Technical Memorandum

Project : MFG Bradley
Date : 25 August 2026
Ref : EC21993-2
Author : Jon Mudd BEng(Hons) MIOA

TITLE : Response to EHO queries

Figure 1: Noise from the operation of the air station

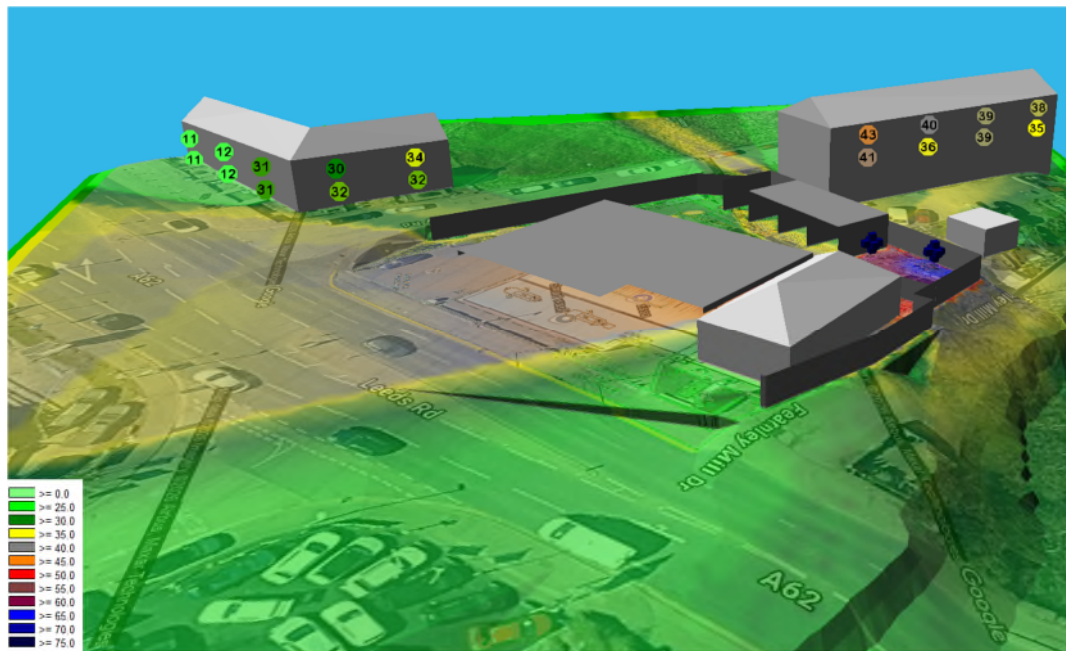
The EHO also noted that no noise impact assessment had been undertaken from the operation of the new air and water stations that are proposed to be installed. The following presents an assessment of the expected noise from the operation of the proposed new air and vacuum stations.

Using the same CadnaA model and the published noise data, the below Figures 1-3 present the noise levels calculated for the surrounding area based on the operation of the each station.

The results of the noise modelling show that the most affected dwellings, which will be 20-30 Quarry Road, as summarised below:

Noise Source	Period	20-30 Quarry Road
Air Station	Any Time	43 dB(A)
Vacuum Station	Any Time	34 dB(A)

The table summarises that the typical background noise levels on site during the daytime and evening time are 51-52 dB(A). Noise from the operation of the air station will be at least 8dB below the typical background noise level. Noise from the operation of the vacuum station will be at least 17dB below the evening background noise level.

During the night time the typical background noise level is 44dB(A) and noise from the operation of the air station will be 1dB below this level and noise from the operation of the vacuum station 7dB below. Even the combined operation if both stations were to be in use simultaneously would be no more than the typical background noise level.

Based on noise from the operation either or both stations being no more than the typical background noise level the noise impact could be considered to be low.
